3V3 + 2V5

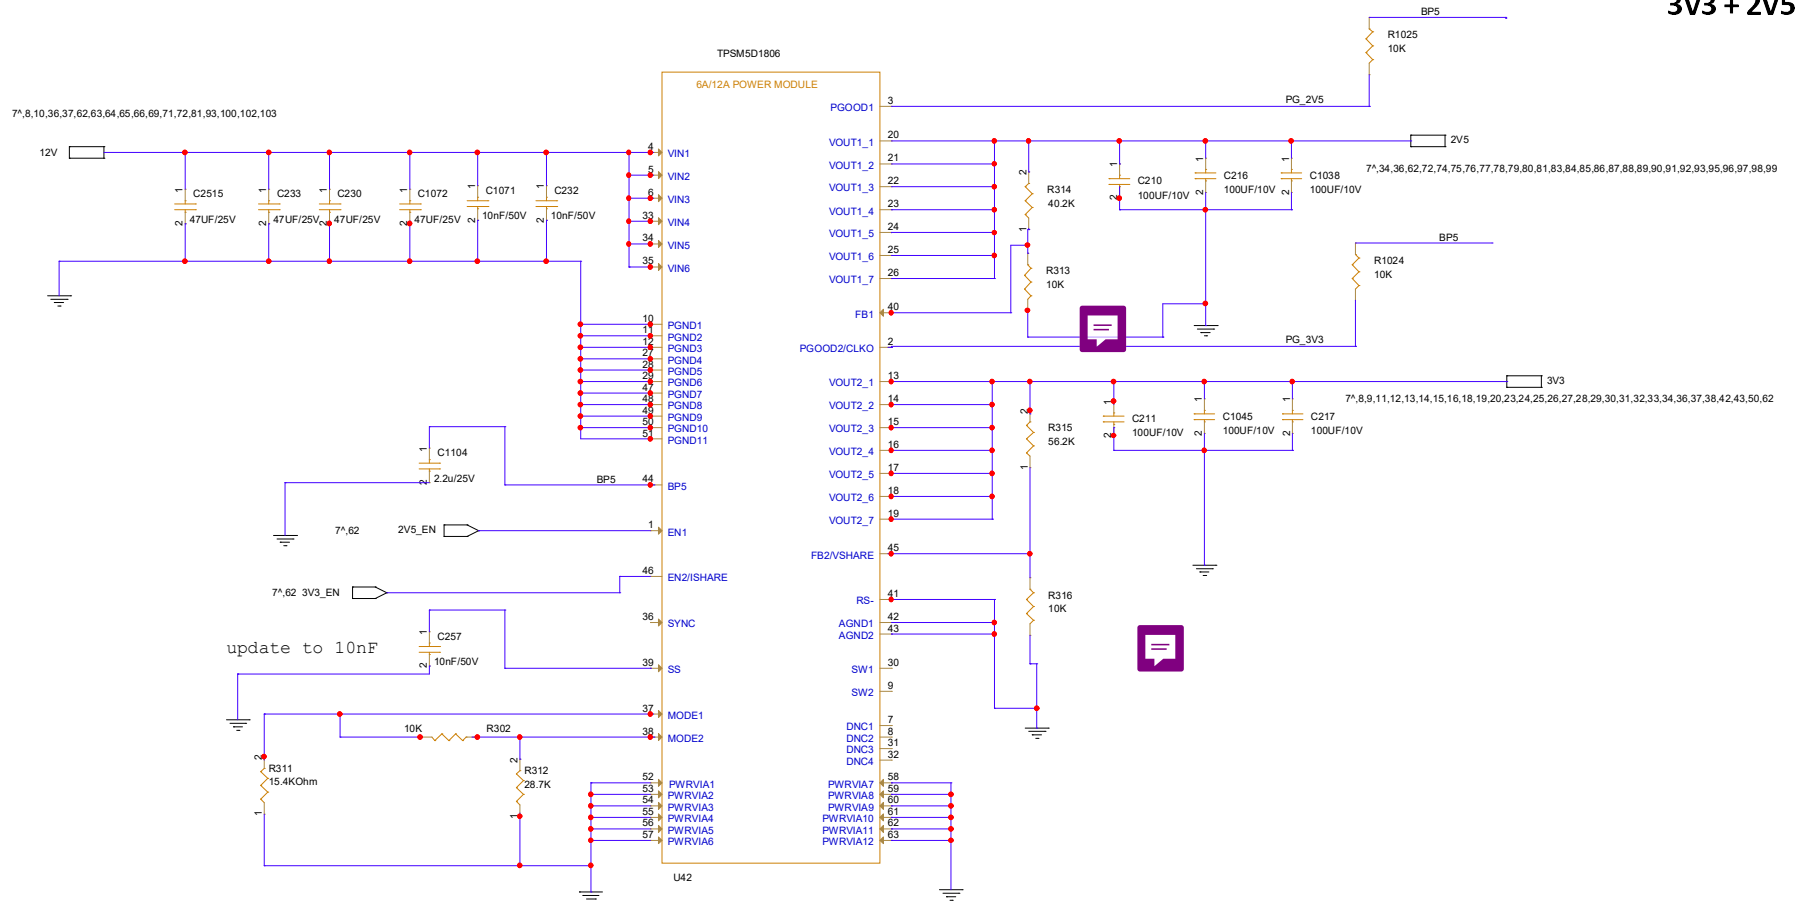
MODE, SS, BP, FB
PINS SHOULD BE CONNECTED TO AGND SEPARATELY
AGND SHOULD BE KEPT AWAY FROM NOISY PGND.
CONNECT ON A SINGLE POINT
